Highway Development Control Consultation Response

Planning Application Ref: 2023/06953

Site Address: Cushlea Cottage 3 The Forty Cricklade

Proposal: Proposed gararge

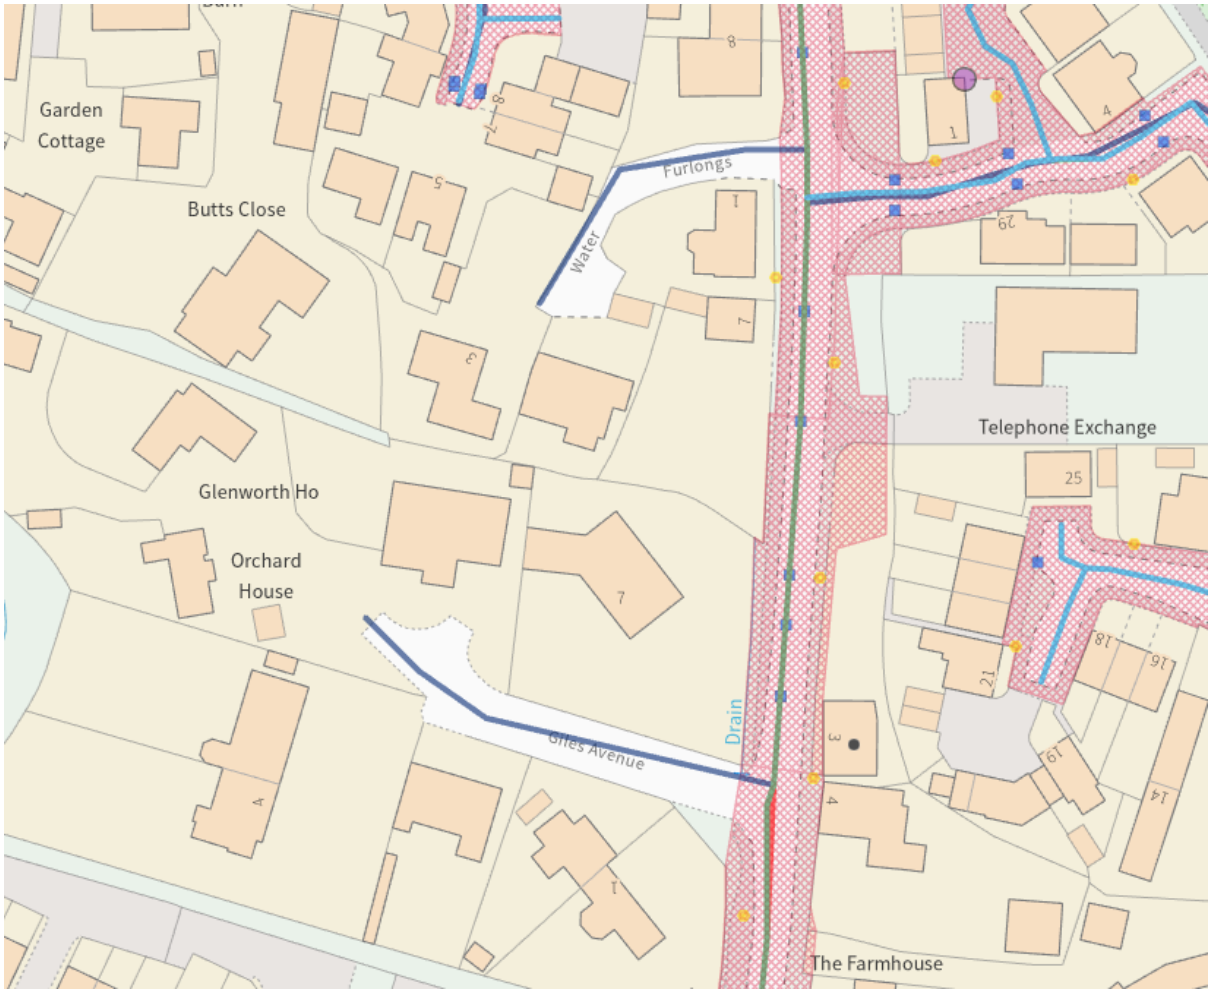
I would bring to the attention of the applicant that the area currently used for parking is dedicated highway (shown below in hatch). It is not usual for allocated private parking to be

located on dedicated highway, however, I note that the parking area has a dedicated dropped kerb which I am assuming has been through the Vehicle Crossing Permission process and therefore given consent by the Local Highway Authority previously. As this application is just an extension to the existing dropped kerb I am raising this matter for information for the applicant rather than as an objection. They may wish to investigate removing the dedication via a stopping Up order under the Town and Country Planning Act.

Therefore, in summary, I am minded that the current parking area accommodates 3 car spaces and the orientation of the garage means that it is not likely to be used for parking but rather storage). However, the application does provide an opportunity to improve the current arrangement and as such I am minded to add the following conditions:

No development shall commence on site until visibility splays have been provided between the edge of the carriageway and a line extending from a point 2.4m metres back from the edge of the carriageway, measured along the centre line of the access, to the points on the edge of the carriageway 43 metres to the North and 43 metres to the South from the centre of the parking area in accordance with plans to be submitted to and approved by the Local Planning Authority. Such splays shall thereafter be permanently maintained free from obstruction to vision above a height of 900mm above the level of the adjacent carriageway.
REASON: In the interests of highway safety.
